Addendum/Addenda

No./N° 2

Project Description / Description de projet M19 Stores Amalgamatim Phase 1		
Solicitation No./ N° de sollicitation 17-22098	Project No./N° de projet 5463	W.O. No./N° d'ordre de travail A1-009909/99
Departmental Representative / Représentant Ministériel Janik Leroux	Date November 29, 2017	
Notice: This addendum shall form part of the tender documents and all conditions shall apply and be read in conjunction with the original plans and specifications.		Nota: Cet addenda fait partie intégrale des dossiers d'appel d'offres; toutes les conditions énoncées doivent être lues et appliquées en conjonction avec les plans et les devis originaux.

dwg.no. / dessin no.
5463-E01

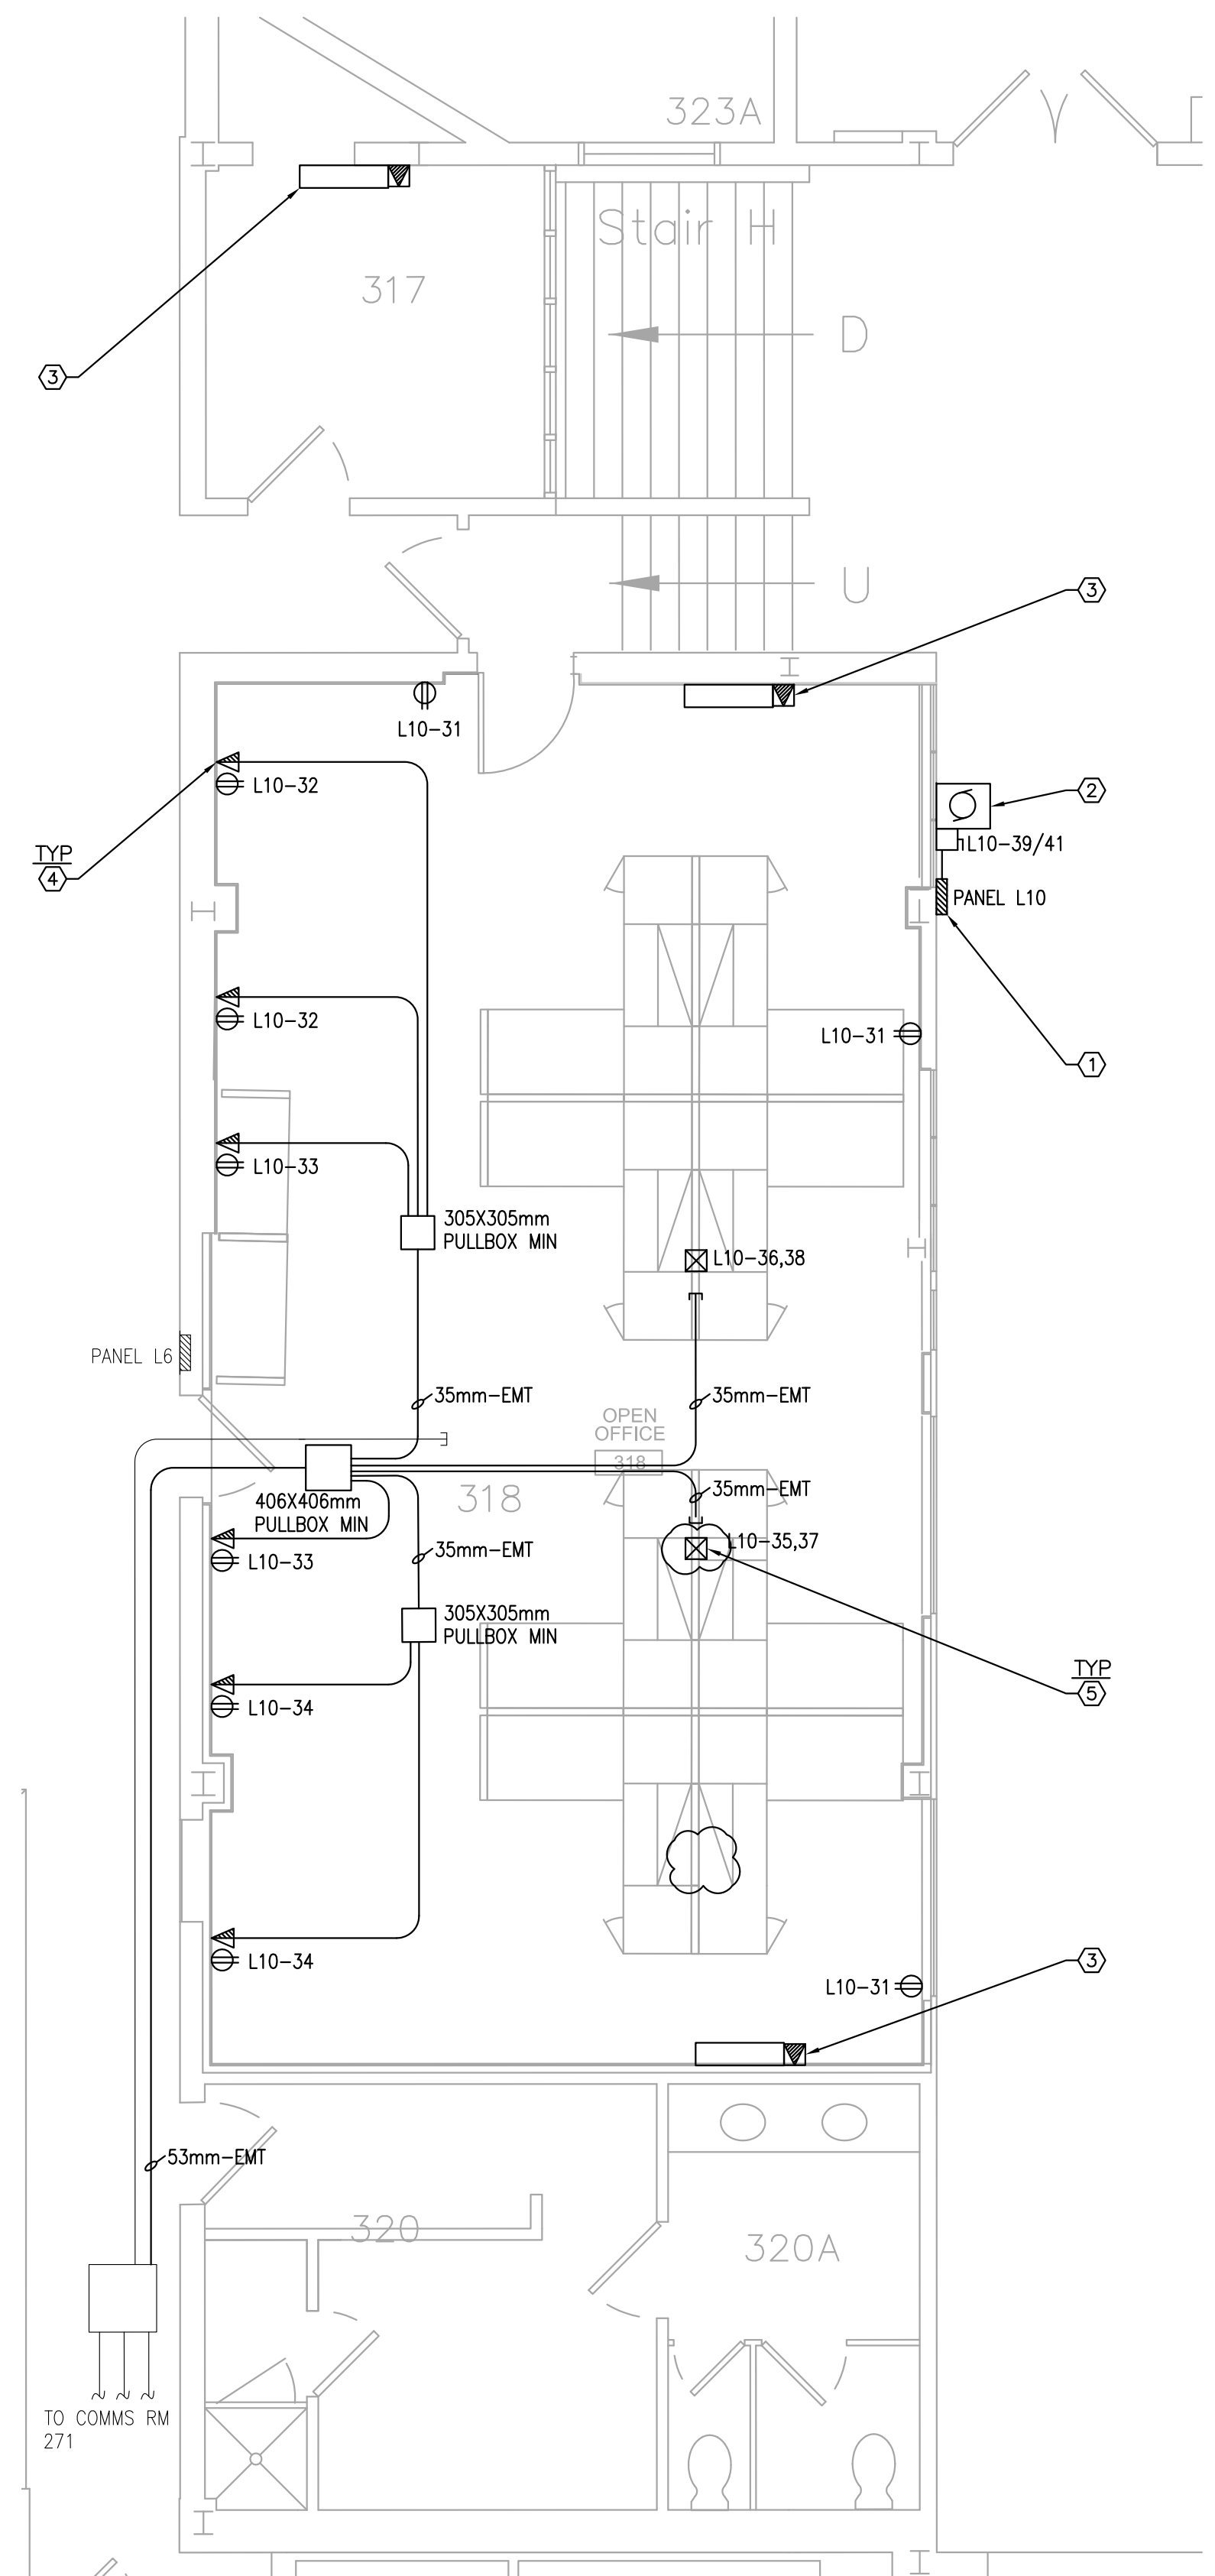
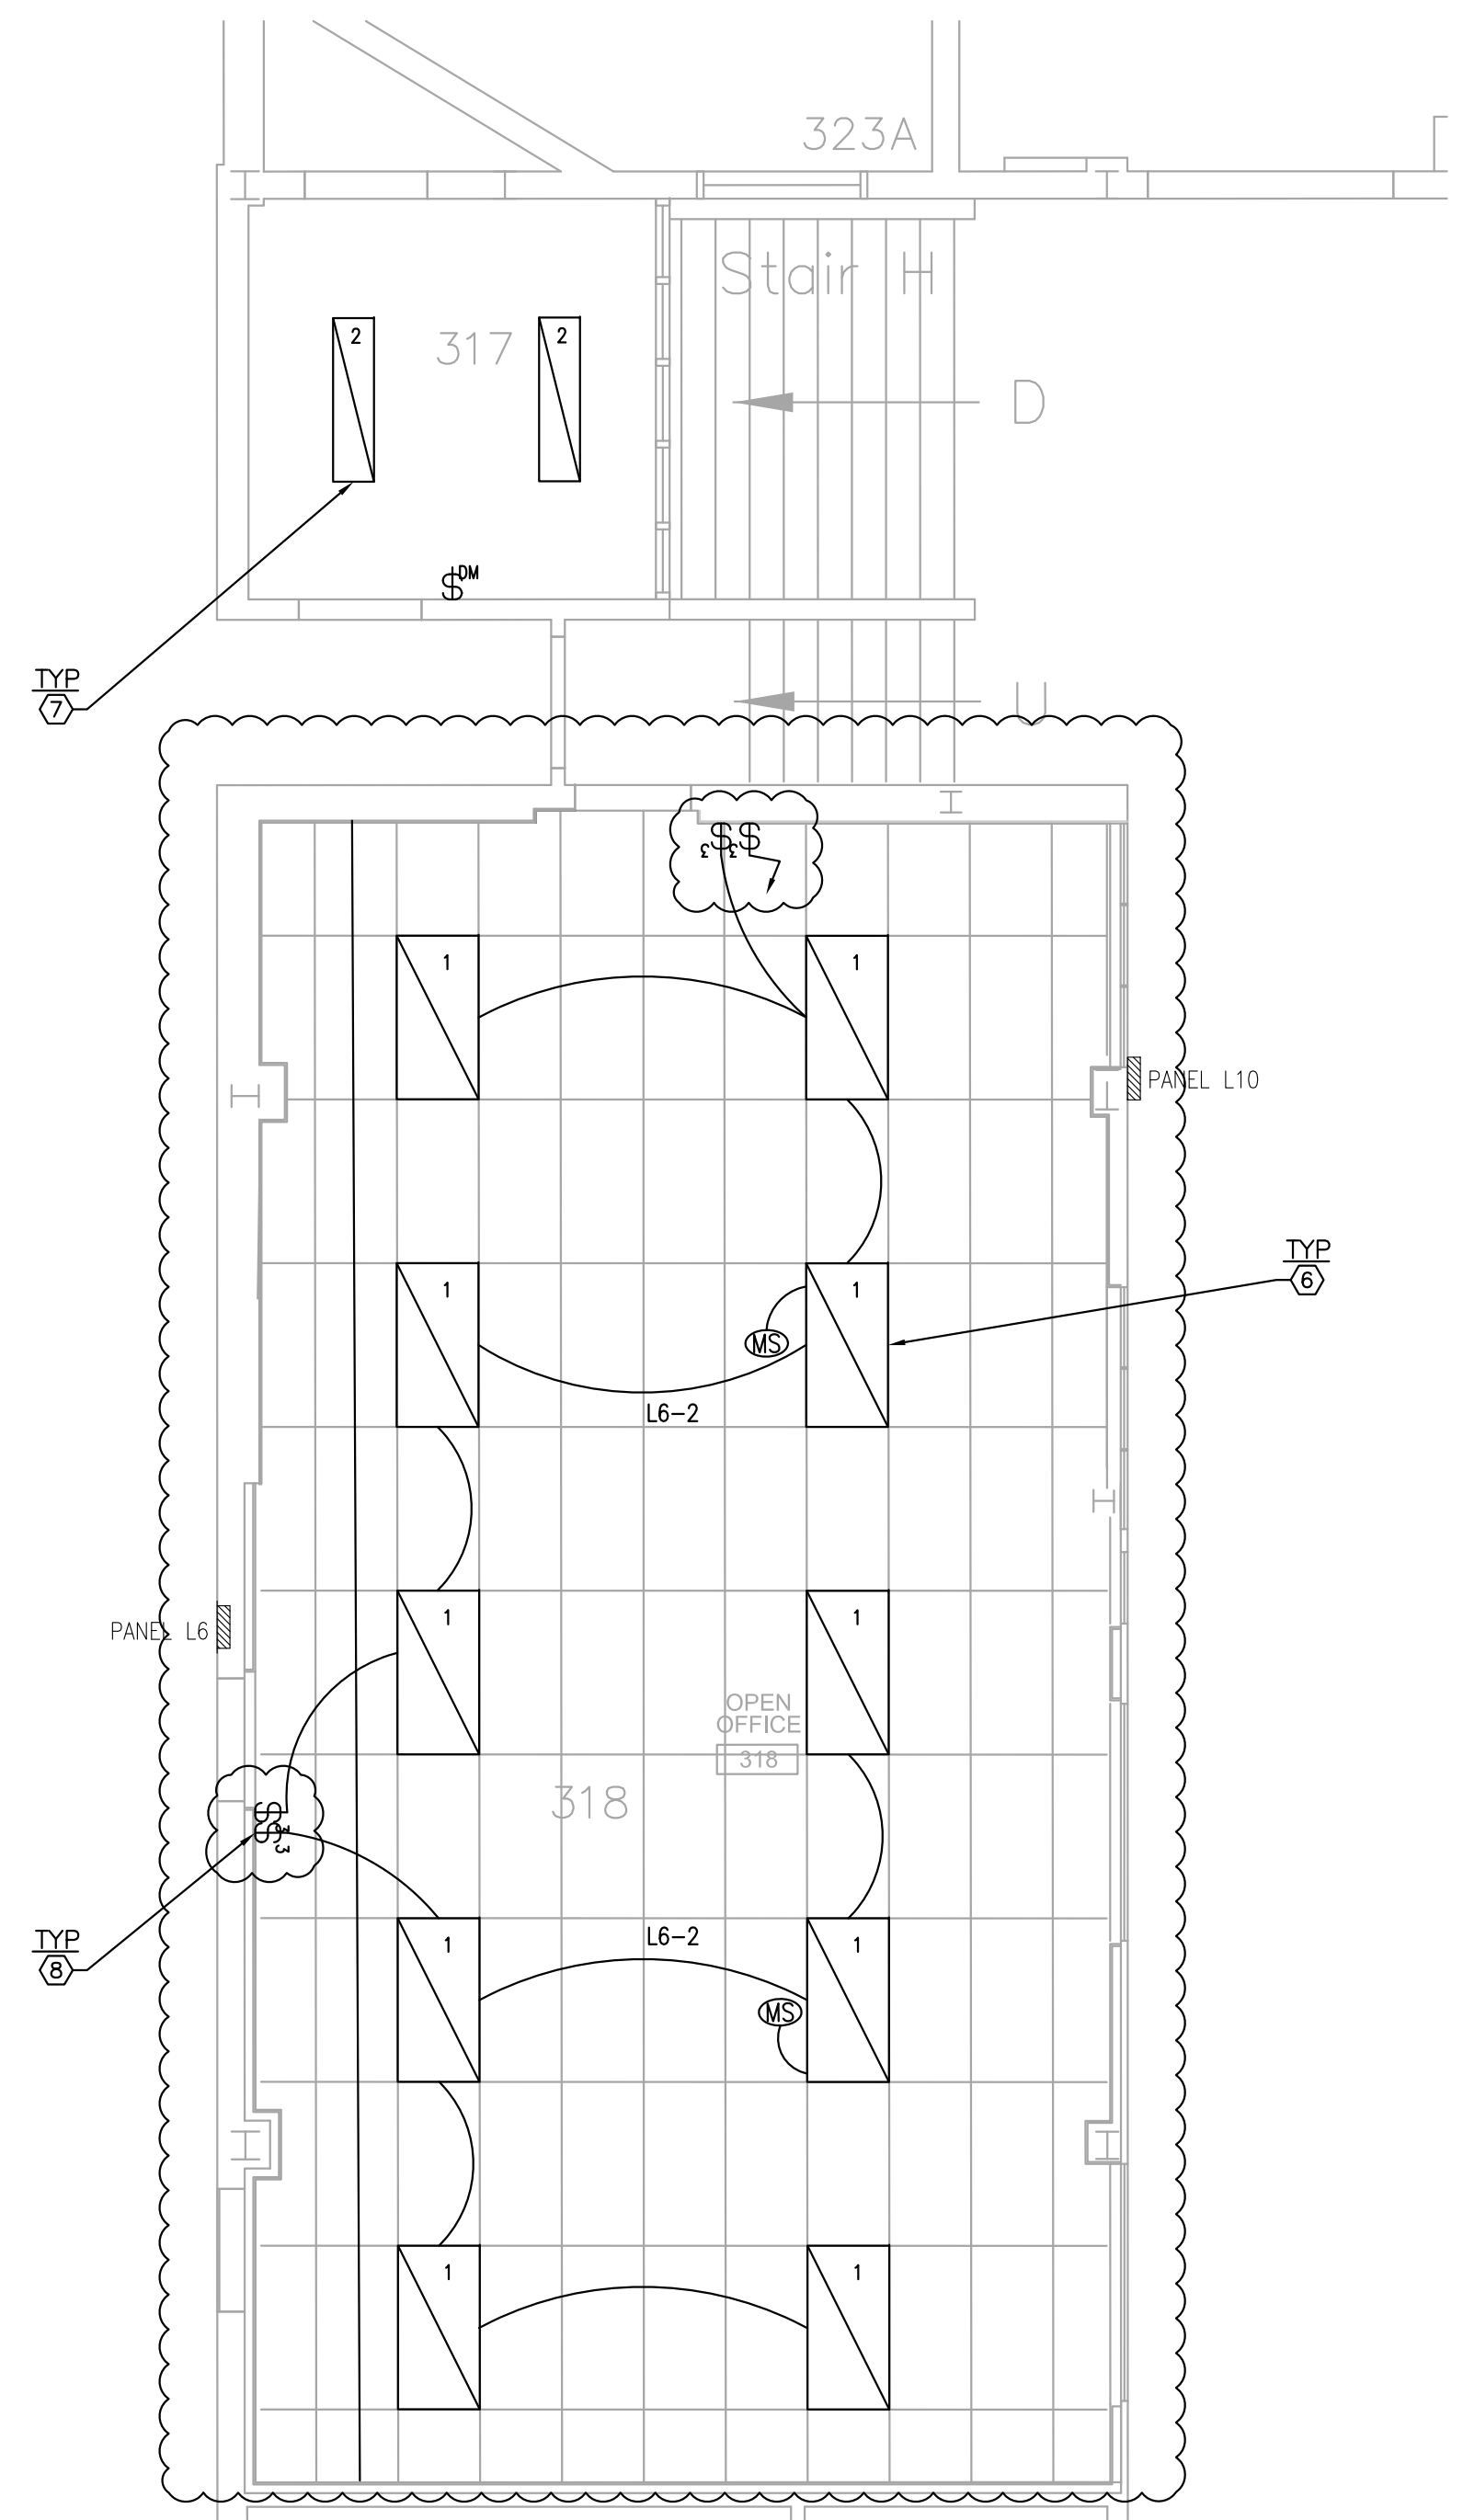
- a. Replace original tender drawing with attached Addendum #2 drawing 5463-E01.
 - i. Changes from tender issue have been clouded.
